HISTORIC AND DESIGN REVIEW COMMISSION

August 16, 2023

HDRC CASE NO: 2023-245
ADDRESS: 227 QUENTIN DR
LEGAL DESCRIPTION: NCB 8411 BLK 6 LOT 63
ZONING: R-6, H
CITY COUNCIL DIST.: 7
DISTRICT: Monticello Park Historic District
APPLICANT: Reed Kirksey/KIRKSEY REED & DIANE
OWNER: Reed Kirksey/KIRKSEY REED & DIANE
TYPE OF WORK: New construction of a 1-story, single-family residence
APPLICATION RECEIVED: June 13, 2023
60-DAY REVIEW: September 26, 2023
CASE MANAGER: Rachel Rettaliata

The applicant is requesting conceptual approval for the construction of a 1-story approximately 1,459-square-foot, single-family residential structure.

SITE PLAN

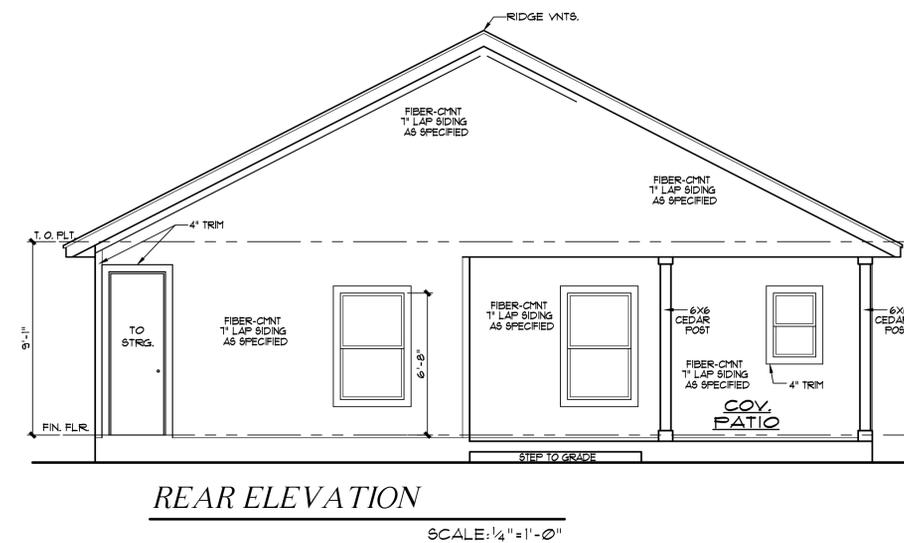
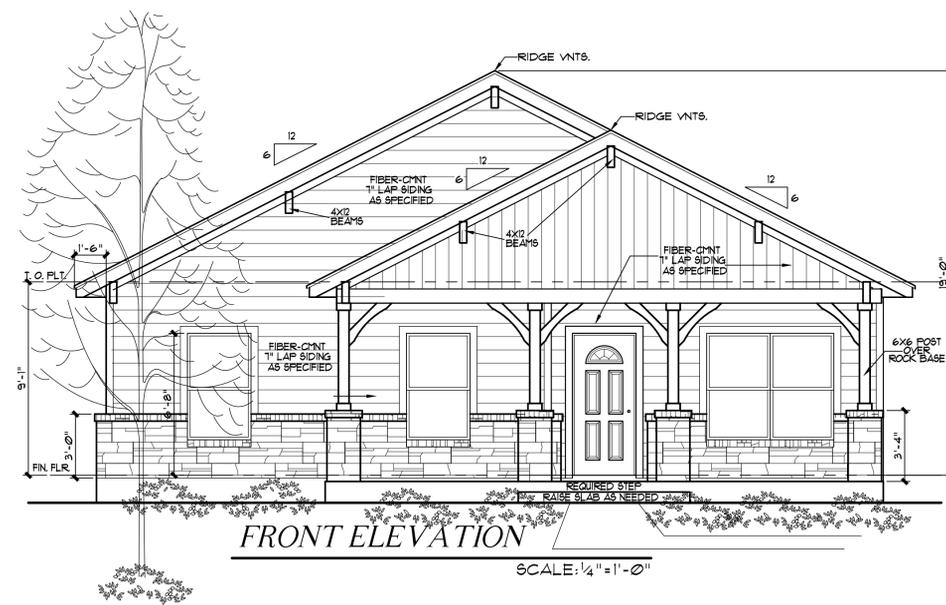
- l. DRIVEWAY – Guideline 5.B.i for Site Elements notes that new driveways should be similar to those found historically within the district in regard to their materials, width, and design. Additionally, the Guidelines note that driveways should not exceed ten (10) feet in width. The property currently features a curb cut. The applicant has proposed to relocate the curb cut further west and to install a 12-foot-wide driveway, 37-foot-long driveway that terminates just beyond the front façade wall plane. Adjacent properties feature approximately 10-foot-wide driveways along the side property line that extend to the rear of the lot. Staff finds the proposal inconsistent with the Guidelines and finds that the applicant should modify the proposal to meet the Guidelines.

- m. FRONT WALKWAY – The applicant has proposed to install a front walkway extending from the center of the front porch to the sidewalk with a secondary walkway from the driveway to the front walkway. The Guidelines for Site Elements note that front yard walkways and site work should appear similar to those found historically within the district in regard to their materials, width, alignment and configuration. The 200 block of Quentin features front walkways that are approximately 4 feet wide and extend linearly from the front porch entries to the sidewalk. Staff finds the proposal appropriate and finds that a fully dimensioned site plan should be submitted showing the proposed width for the front walkway.

- x. That the applicant proposes a driveway that is consistent with the Historic Design Guidelines based on finding l and submits an updated measured site plan to staff for review featuring a driveway that does not exceed 10 feet in width and a driveway apron that does not exceed 12 feet in width prior to returning to the HDRC.

- xi. That the applicant submits a final dimensioned site plan featuring a front walkway that is 4 feet in width to staff for review prior to returning to the HDRC based on finding m.

RIGHT ELEVATION
SCALE: 1/4" = 1'-0"

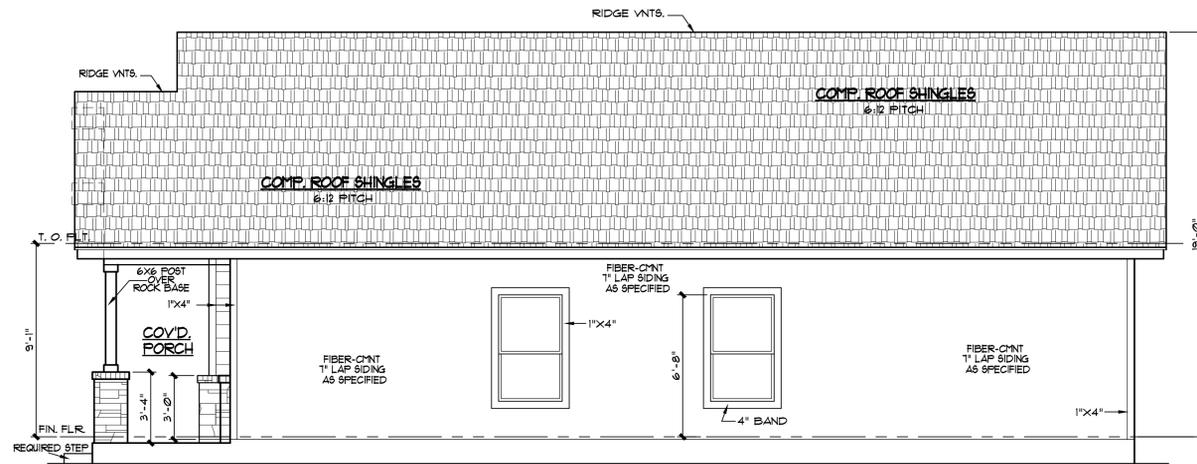
- k. ARCHITECTURAL DETAILS – Guideline 4.A.i for New Construction states that new buildings should be designed to reflect their time while respecting the historic context. While new construction should not attempt to mirror or replicate historic features, new structures should not be so dissimilar as to distract from or diminish the historic interpretation of the district. The applicant has proposed exposed rafter tails at the two front gables, wood columns on rock bases with bracketing for front porch supports, a 3-foot-tall skirt of rock cladding, and 6”x6” cedar posts for the rear porch supports. The drawings show that the proposed rock skirt wraps around the front façade and extends 2’-6” onto the west elevation but does not extend onto the east elevation. Historic structures in the district rarely feature skirting that extends to 3 feet in height along the façade. Staff finds that the height of the skirting should be reduced and that the extension of the skirting should be uniform on the side elevations.

JF: On the left elevation, you have turned the corner with your stone wainscot but that is not the same for the right elevation. I would recommend that those skirts should match. If you are planning to fence the property, coming to the skirt with the fence would be a good stopping point for privacy fencing.

- ix. That the height of the skirting is reduced and that the extension of the skirting is uniform on the side elevations based on finding k. The applicant is required to submit updated drawings to staff for review prior to returning to the HDRC.

ROOF PLAN
SCALE: 1/8" = 1'-0"

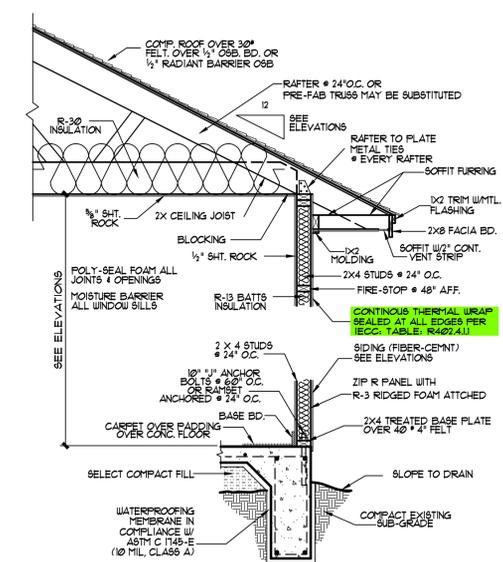
- f. **ROOF FORM** – The applicant has proposed a front gable roof form with overhanging eaves and a projecting front gable porch roof. According to Guideline 2.B.i for New Construction, new construction should feature roof forms that are consistent with those predominantly found on the block. The adjacent structures on Quentin feature cross gable, side gable, and hip roof forms. The structures immediately adjacent to the property predominately feature low-slope roofs. The proposed roof form features a 6:12 pitch and a wide gable span. Staff finds that the applicant should modify the roof pitch to be in keeping with the lower-sloped roofs along this block of Quentin.

MS: I will agree with Lisa's roof suggestions. There are houses that have large roof planes; however, the ridge height is usually lower. This roof, even though it is a simple gable roof form, it does seem awkward and tall. You can play with the roof design and there are several different solutions so that the roof form can break up that mass in manageable dimensions.

- iii. That the applicant modifies the roof pitch to be in keeping with the predominant lower-sloped roofs of adjacent structures based on finding f. Updated elevation drawings must be submitted to staff for review prior to returning to the HDRC.
